Fire Rebuild Design Guidance for System Hardening

This document describes the standard Overhead design requirements for all **new construction and reconstruction work in Tier 2 and Tier 3 Fire Areas, and Zone 1 (tree mortality) areas**. In many cases, the requirements listed are current standard requirements or special application requirements used in new construction.

This bulletin supersedes bulletin TD-9001B-009 Rev 1.

ATTACHMENT 1: Fuse Application Decision Tree

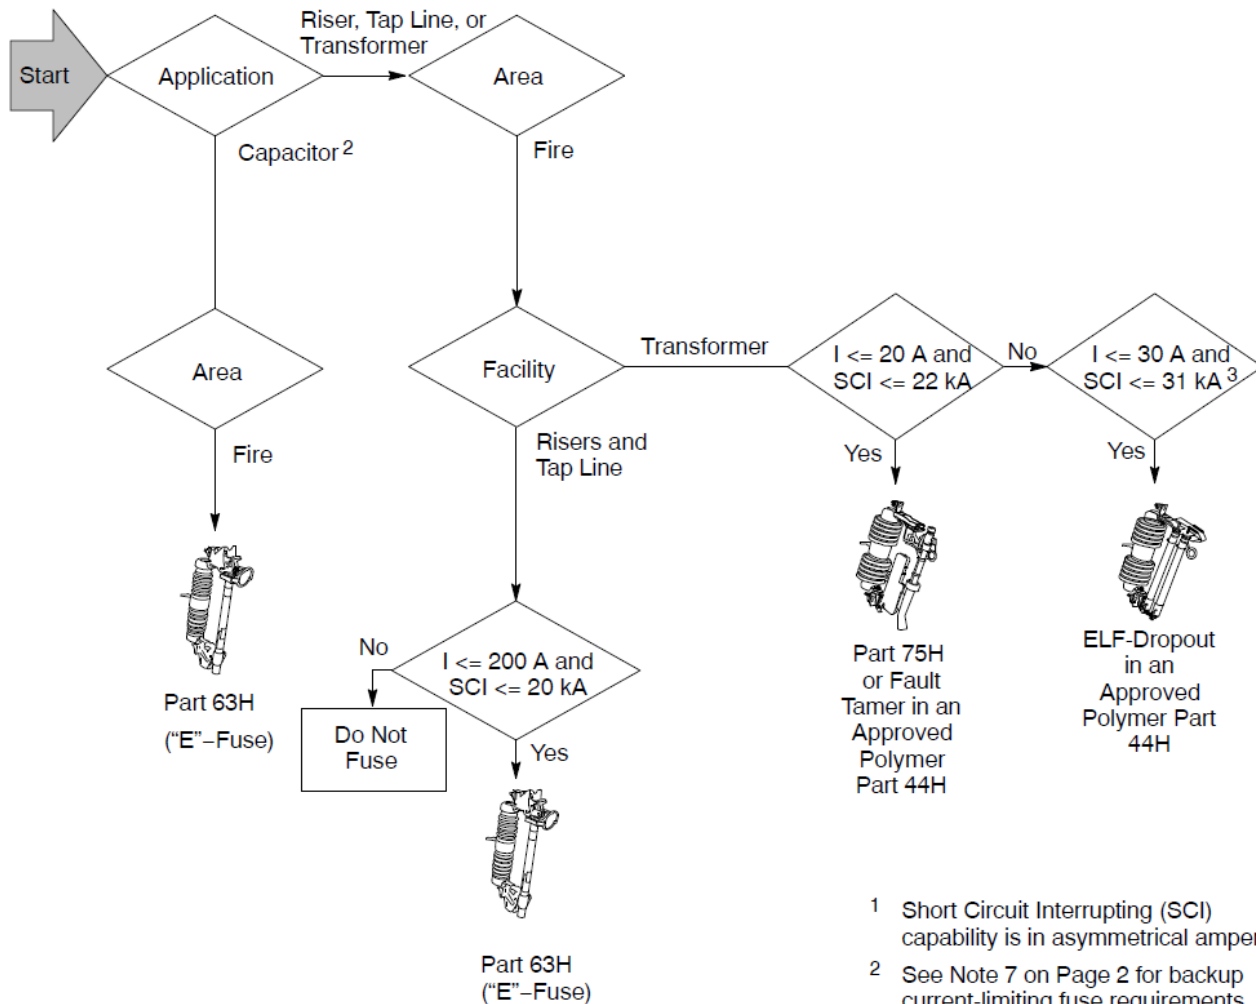
1.21. Install Cal Fire Exempt equipment only – no new, non-exempt equipment shall be installed; install ELF or Fault Tamer fuses for transformer protection and E-power fuses for lateral and riser protection (see Fuse decision tree). Install E fuses when fusing is required in fire areas. If coordination is not possible, installing an ELF fuse ² at the discretion of the responsible distribution engineer is acceptable.	015225	Current standard for high fire areas, reduces risk of wildfire ignition caused by equipment operation

Note: Install Polymer Part 44H with ELF dropout door in the event coordinating with the appropriate E fuse is not possible
